REGULAR MEETING AGENDA

Tuesday, October 08, 2024 6:30 P.M.

- 6. OLD BUSINESS
- 7. NEW BUSINESS
 - A. SPECIAL LAND USE SHEETZ 755 S. HEWITT ROAD, 2103 AND 2059 W. MICHIGAN AVENUE PARCEL K-11-18-100-019, K-11-39-350-023, AND K-11-39-350-022 TO CONSIDER THE SPECIAL CONDITIONAL USE PERMIT APPLICATION OF SKILKEN GOLD TO PERMIT THE CONSTRUCTION OF A 6,139 SQ. FT. GAS STATION / CONVIENENCE STORE WITH 8 GAS PUMPS FOR A 7.36-ACRE SITE ZONED RC, REGIONAL CORRIDOR WITH A SITE TYPE C DESIGNATION.

- B. PRELIMINARY SITE PLAN SHEETZ 755 S. HEWITT ROAD, 2103 AND 2059 W. MICHIGAN AVENUE PARCEL K-11-18-100-019, K-11-39-350-023, AND K-11-39-350-022 TO CONSIDER THE PRELIMINARY SITE PLAN APPLICATION OF SKILKEN GOLD TO PERMIT THE CONSTRUCTION OF A 6,139 SQ. FT. GAS STATION / CONVIENENCE STORE WITH 8 GAS PUMPS FOR A 7.36-ACRE SITE ZONED RC, REGIONAL CORRIDOR WITH A SITE TYPE C DESIGNATION.

LANDSCAPING DETAILS

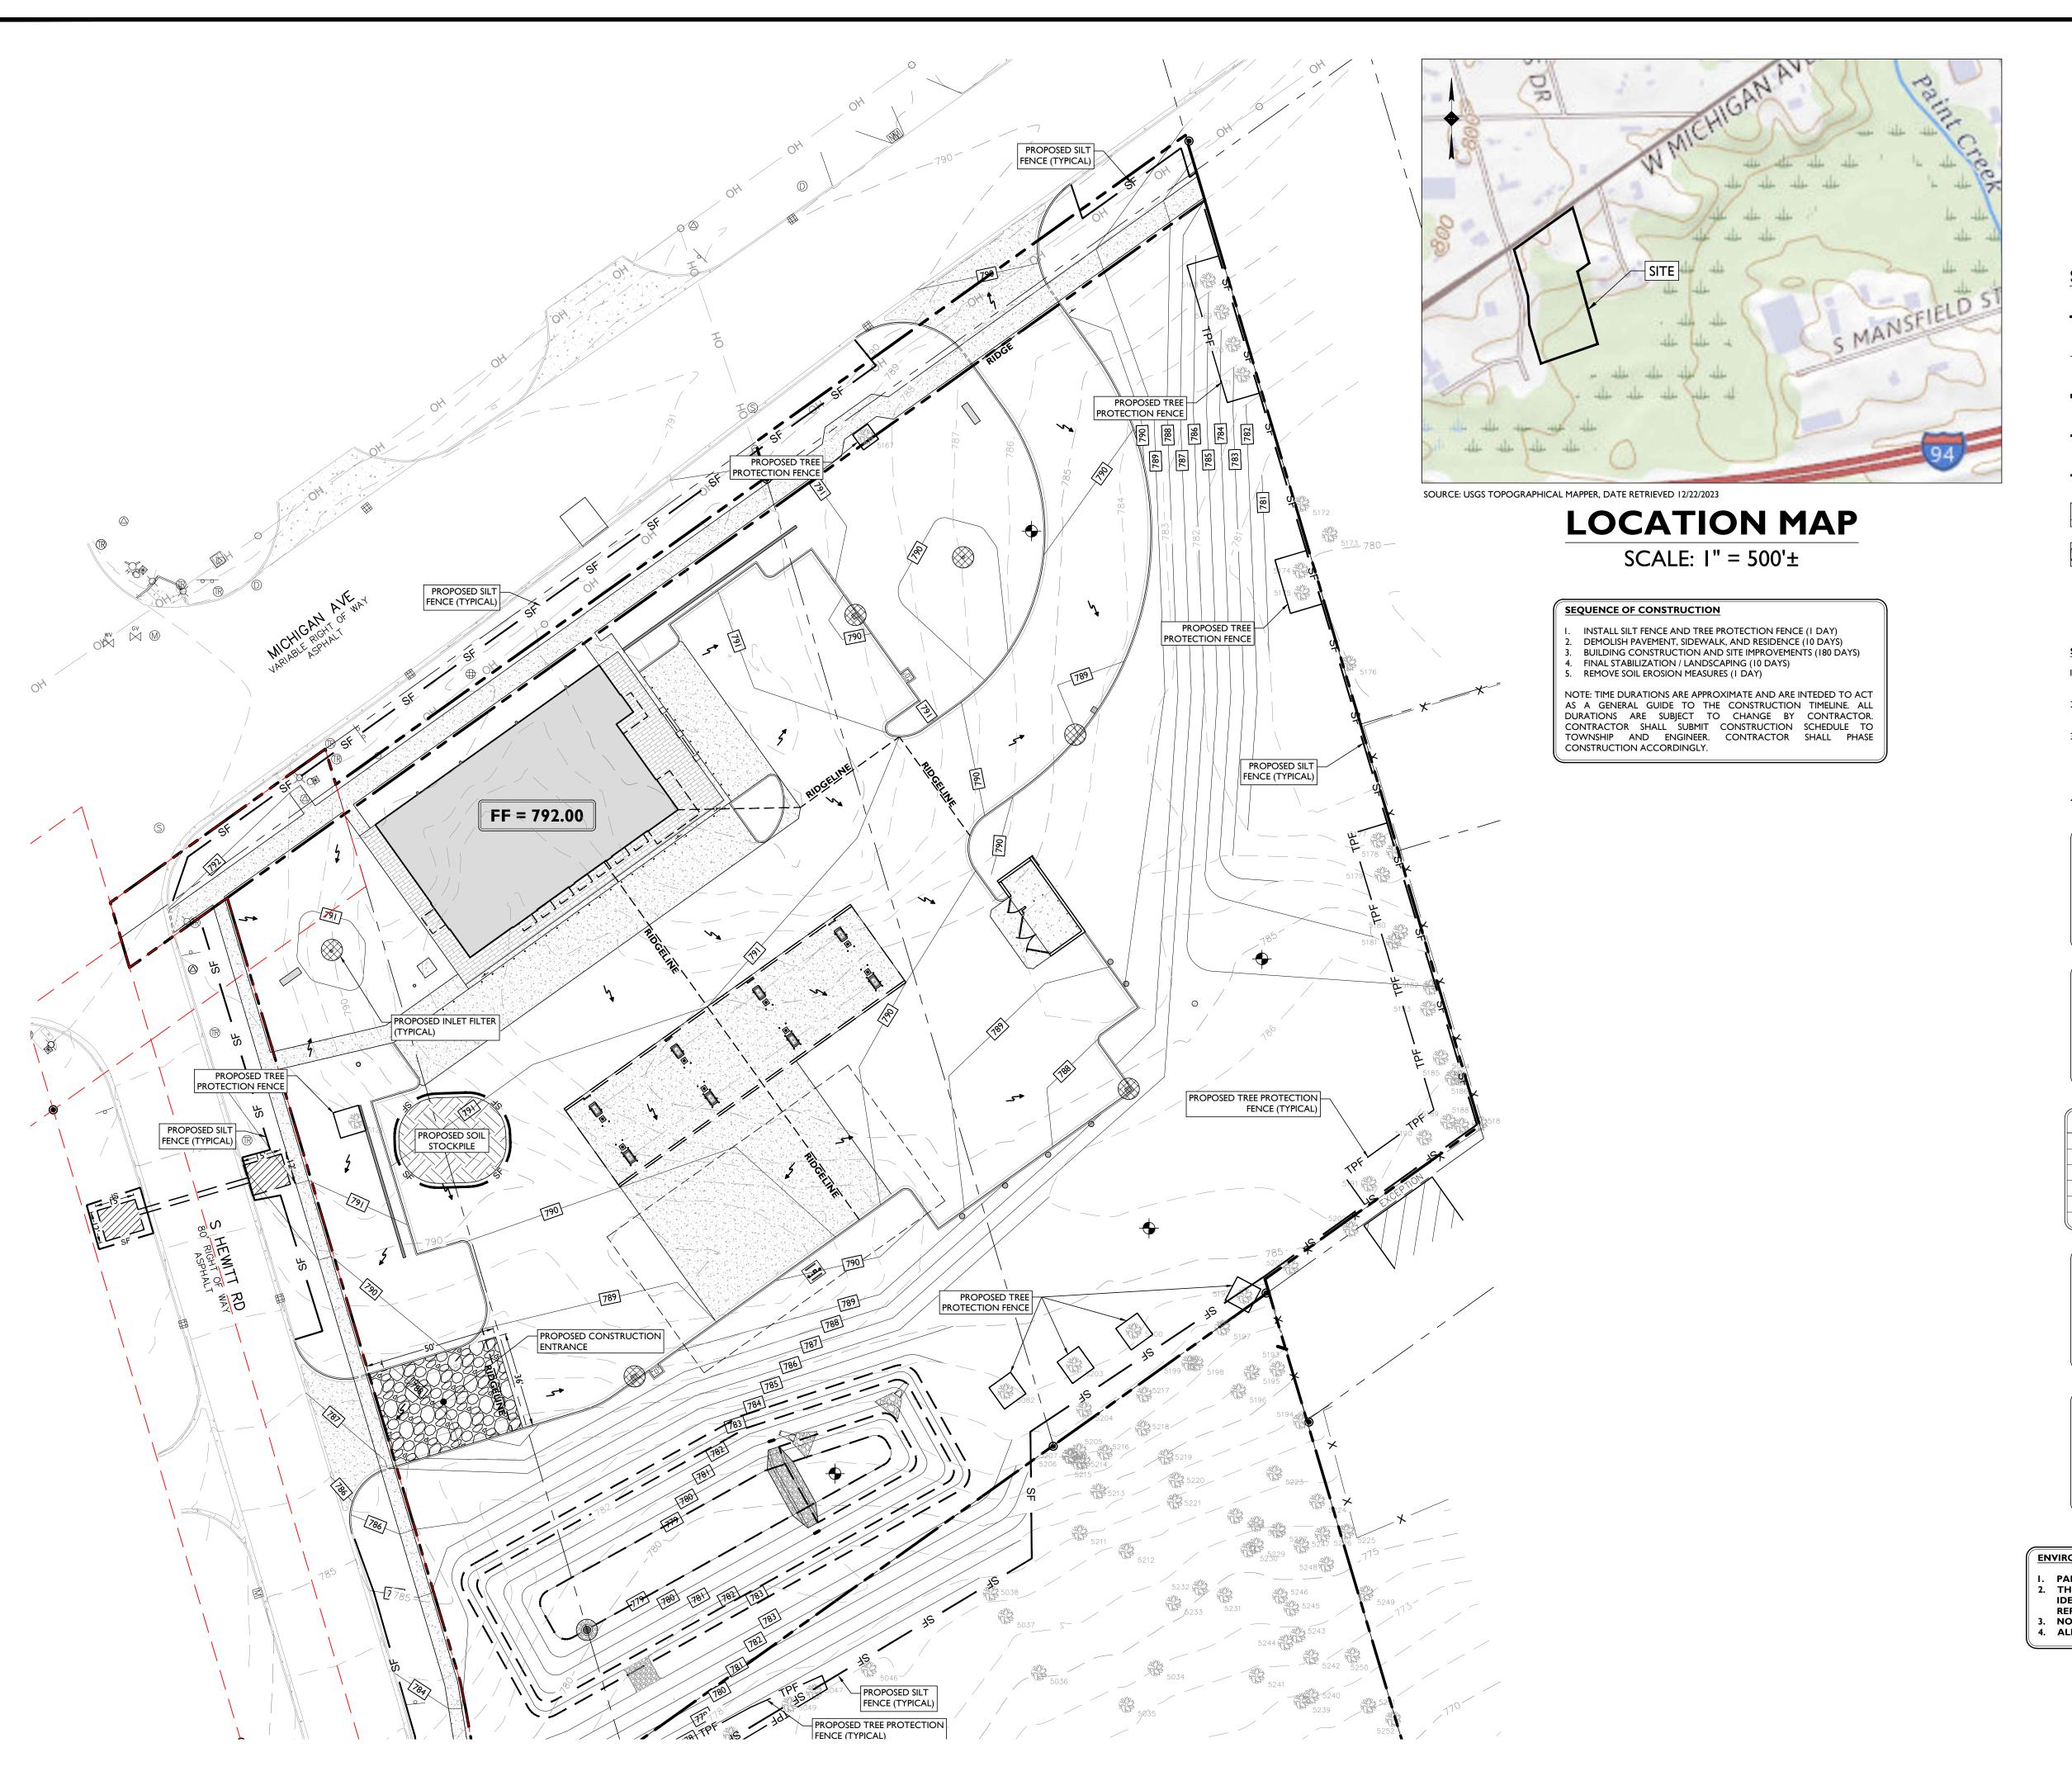
- a. If it was to denote the area of the basin plantings, the hatched areas should be expanded to include both the basin and buffer areas.
 - The hatching represents the infiltration basin planting. Mix information has been provided in table-form at the bottom of Sheet C-15.

C-20

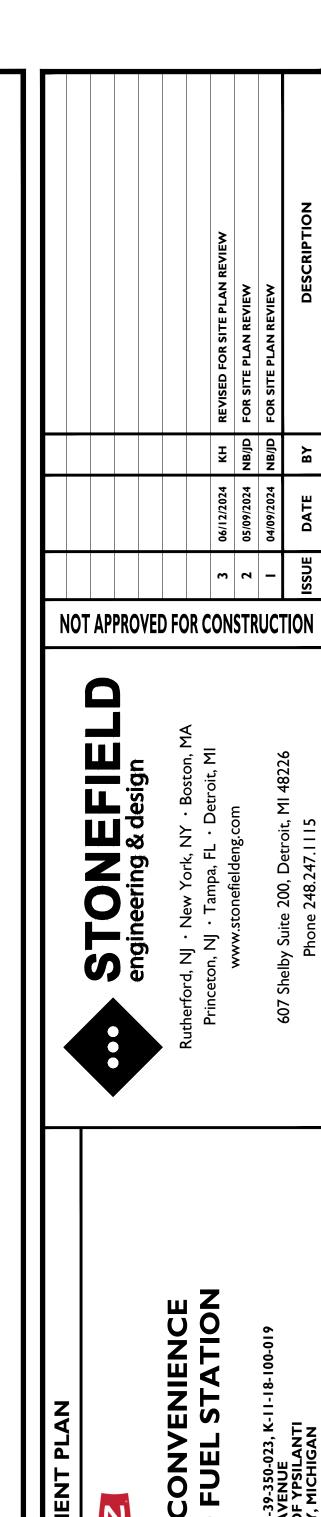
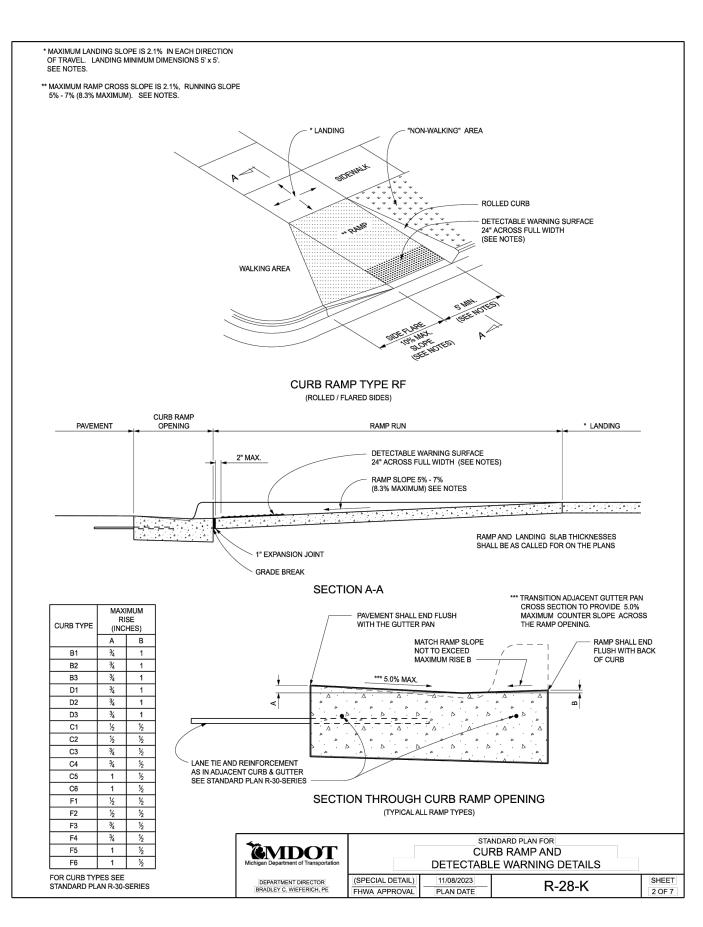
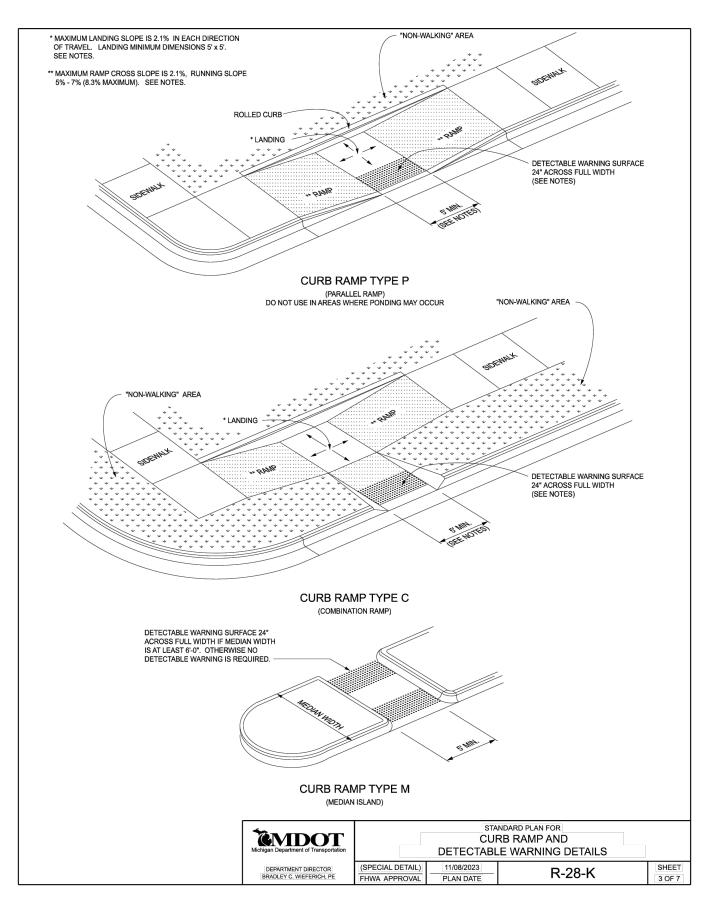
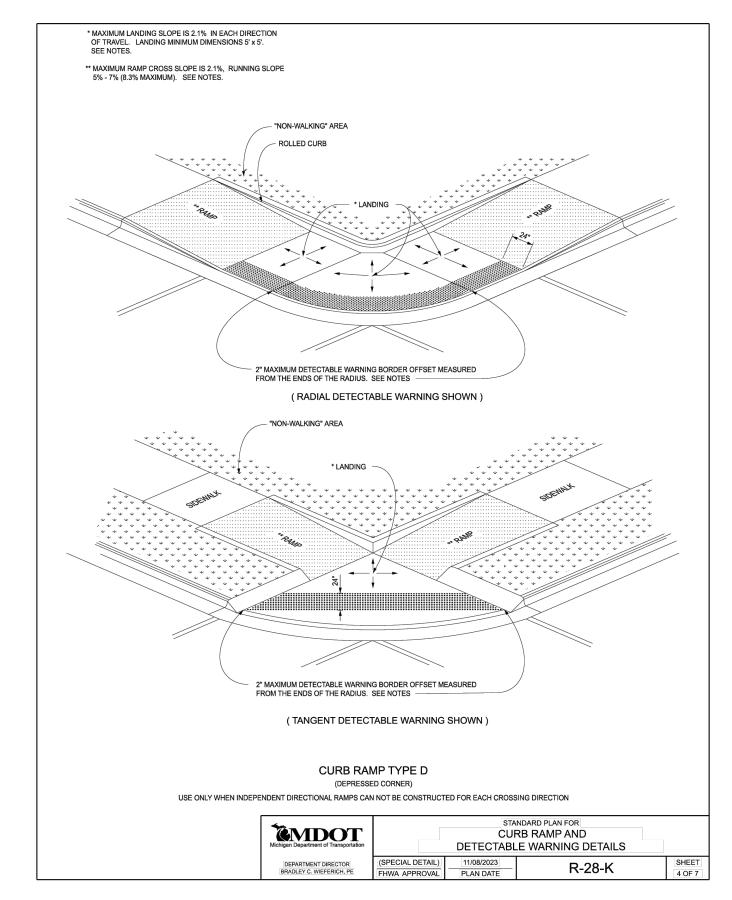
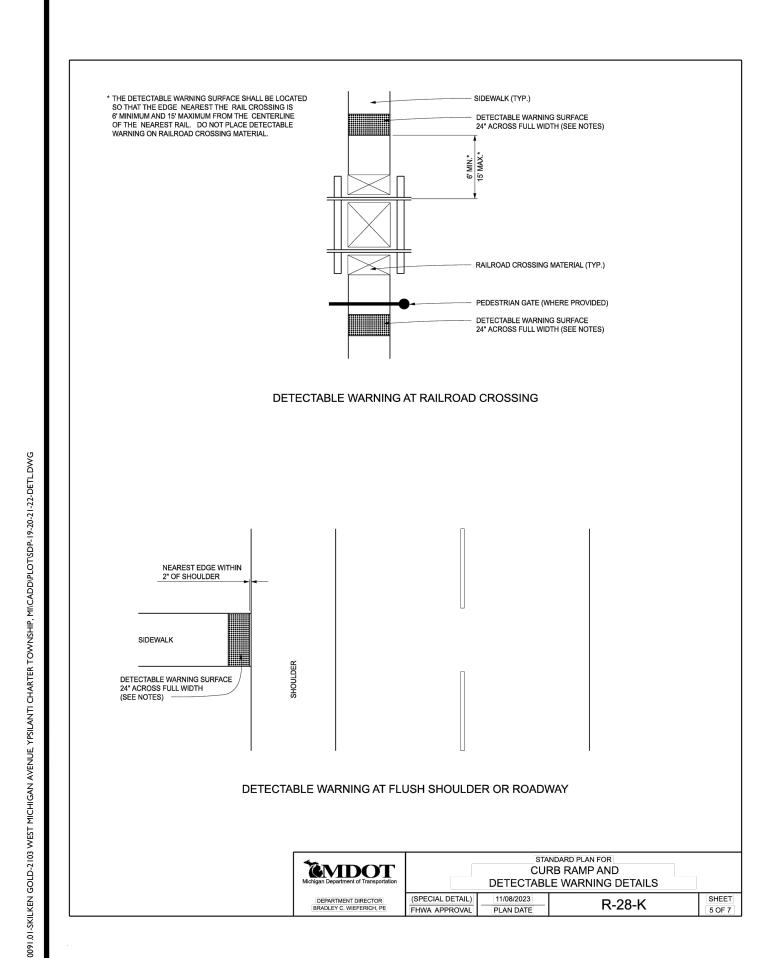
This section requires that the plans identify how the trees "to remain" will be protected during construction. A Tree Protection fence detail is provided on Sheet C-20, Construction Details. A symbol showing the location of this fencing is shown on Sheet C-18, Soil Erosion and Sedimentation Plan around all trees to remain. This symbol needs to be added around "trees to remain" on the following sheets during Final Site Plan review:
